Ref: Groundwater Sustainability Plan  
Borrego Valley Groundwater Basin  
Borrego Springs Sub-

Re: Suggested changes to the Groundwater Sustainability Plan Draft for the Borrego Valley Groundwater Basin (SGMA Draft): Promote Bioretention Basins and Greywater Systems

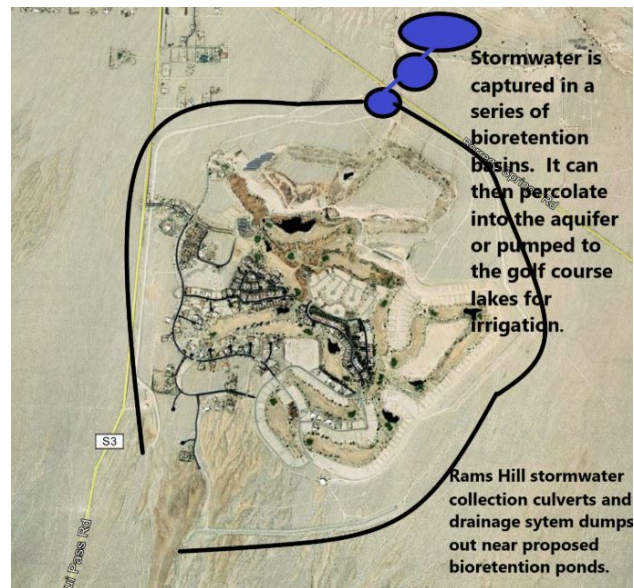
This picture of the sixth hole at Rams Hill was taken in February 2019. It demonstrates that the golf course is a large bioretention basin that has captured hundreds of acre feet of stormwater runoff that has recharged the aquifer over the years.

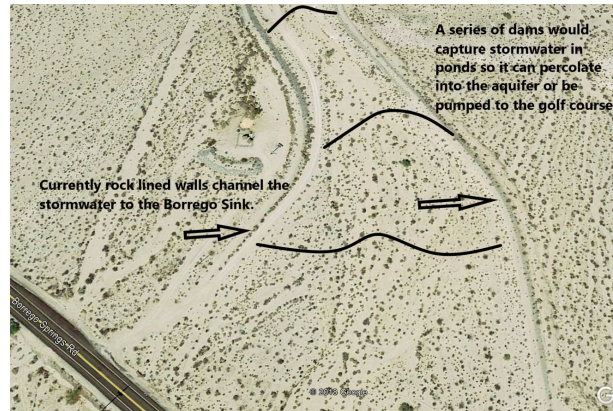
This picture shows the existing rock lined channels (east of Borrego Springs Road and near the BWD Reclamation Plant) that direct stormwater to the Sink. If the 4 acres between the rock lined channel walls were excavated to an average depth of 10 feet, they could capture 40 acre feet from one storm. While these storms may be infrequent, climate change may result in more storm events in the future.

Why miss an opportunity to capture stormwater before it is lost to evaporation in the Borrego Sink?
